# WOLF CREEK

WO 96-0037

Subject: Docket No. 50-482: Response to Request for Additional Information Concerning the Revision to Technical Specification 3/4.8.1, "Electrical Power Systems - A.C. Sources"

### Response to Request for Additional Information

Figure 2  
 Typical Full-Load Rejection Test  
 (Page 1 of 1)

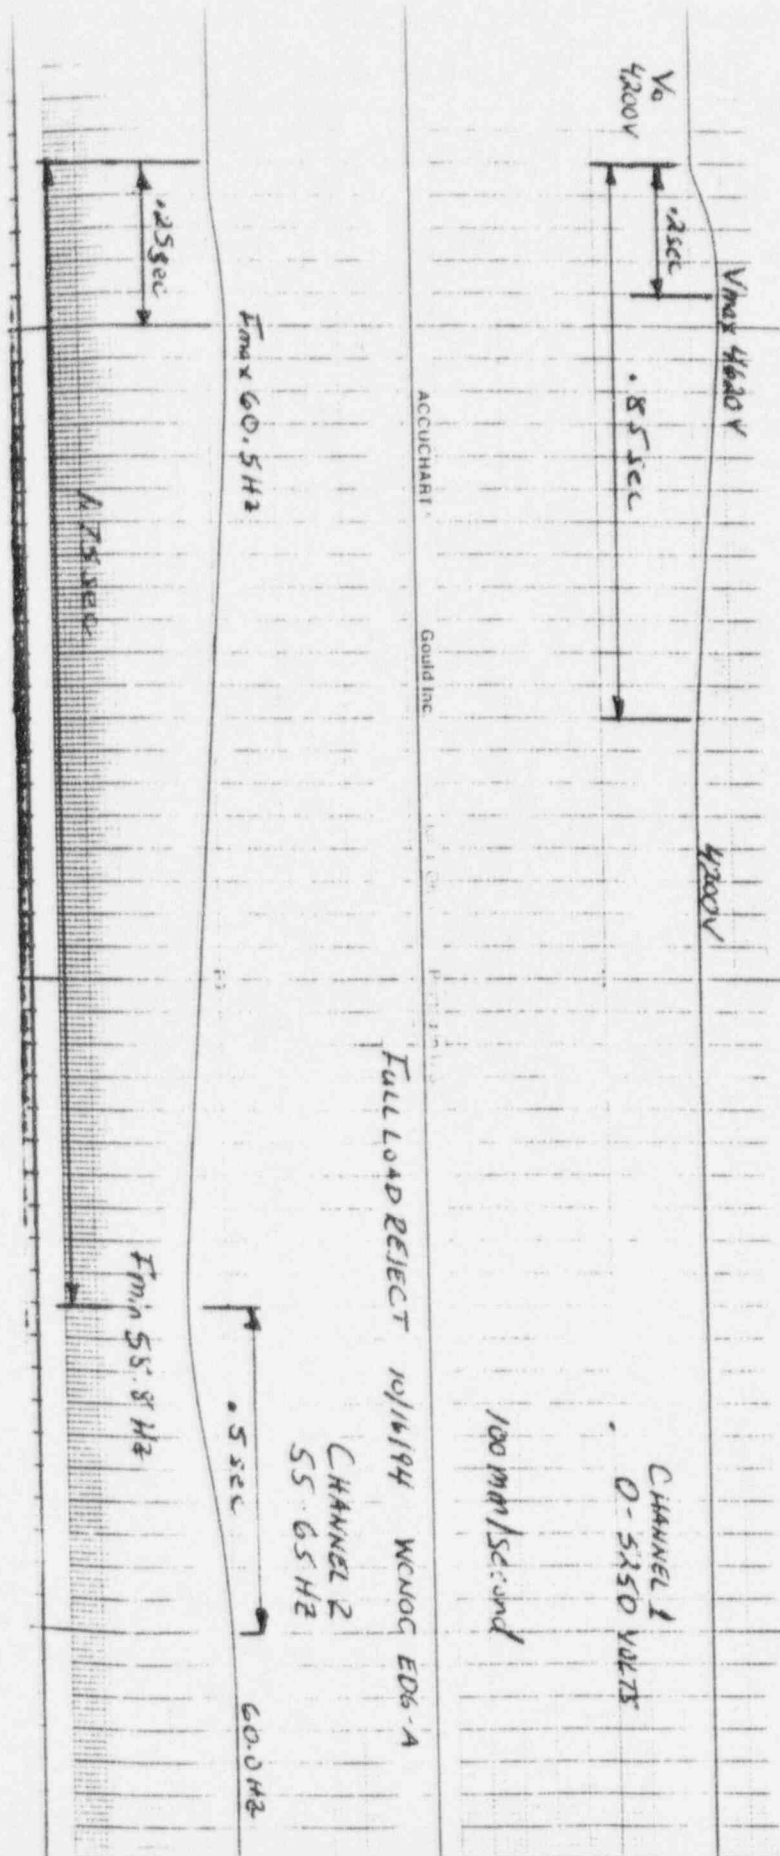
NRC Comment 3. Provide additional justification for removal of Surveillance Requirement 4.8.1.1.2g.2, single-load rejection test, from Technical Specifications.

- A. The single-load rejection test is enveloped by the full load rejection test since the proposed change revises the frequency criteria to  $60 \pm 5.4$  Hertz which is the current frequency for the single largest load rejection test. Figure 1 provides a strip chart recording for the Callaway Plant for a typical full-load rejection test. Figure 2 provides a recording for Wolf Creek Generating Station (WCGS) of a typical full-load rejection test.
